APPLICATION AND
FINAL PLAT CHECKLIST

Name of Proposed Subdivision Harris Heights

Name of Proposed Development: Harris Heights, Phase I

Re: Harris Heights Addition
Phase I
ROK 83203

HARRIS HEIGHTS ADDITION PHASE ONE

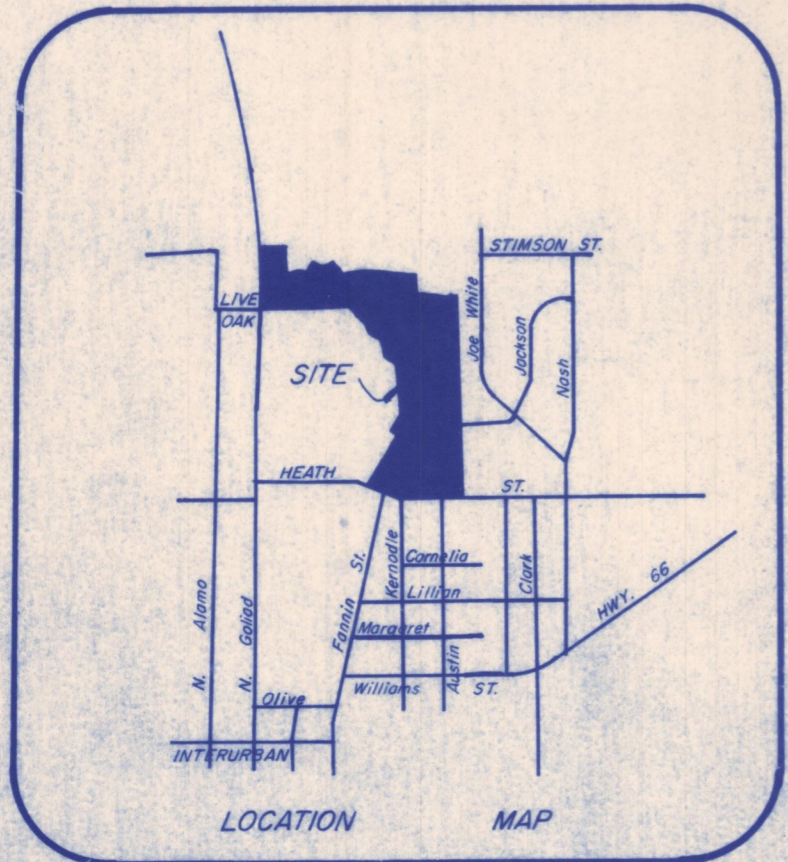
- Needs:
1. Location map
 2. Lot and Block numbers in Wade Addition
 3. Legal to match drawing
 4. Point of Beginning
 5. Review shape of Lot 6, Block A
 6. Start Block B with "1" and continue

Staff Comments: We have asked Freese and Nichols to make sure the easements will be wide enough for the drainage way and parallel utility lines. Add letter "E" to curve 9 in table.

1. It would be helpful to include a general location detail on page one.
